APPLICATION NO.	FILING DATE	FIRST NAMED INVENTOR	ATTORNEY DOCKET NO.	CONFIRMATION NO.
09/609,868	07/03/2000	Kenneth Gordon Walker	W2450002	3798

Office Action Summary

DETAILED ACTION

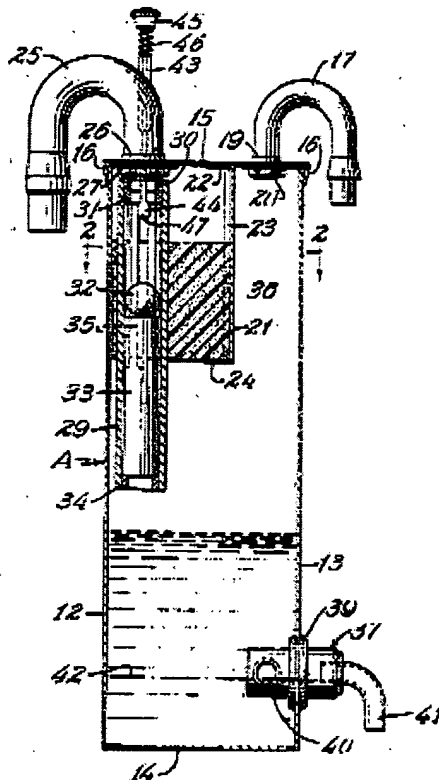
Claims 29, 31, 33 and 36 are rejected under 35 U.S.C. § 102(e) as being anticipated by *Beguiristain* (U.S. Pat. No. 3,612,089).

As to claim 29, *Beguiristain* teaches a lid (15) covering a canister body (12)(13) together forming a canister for receiving fluids, said canister body (12)(13) having side walls and a bottom, said lid (15) comprising:

An inlet port (20) in said lid (15) for inflow of fluids into said canister;

An outlet port (30) in said lid (15) for outflow of fluids from said canister;

A conduit (29) in fluid communication with said outlet port (30), said conduit (29) extending to said bottom of said canister body when said lid (15) is placed in covering relation to said canister body (*see* Fig. 1, below).

As to claim 31, *Beguiristain* teaches a vacuum port (30)(col. 2, lines 26-36).

As to claim 33, *Beguiristain* teaches a check valve (32).

As to claim 36, *Beguiristain* teaches a bottom wall (14).
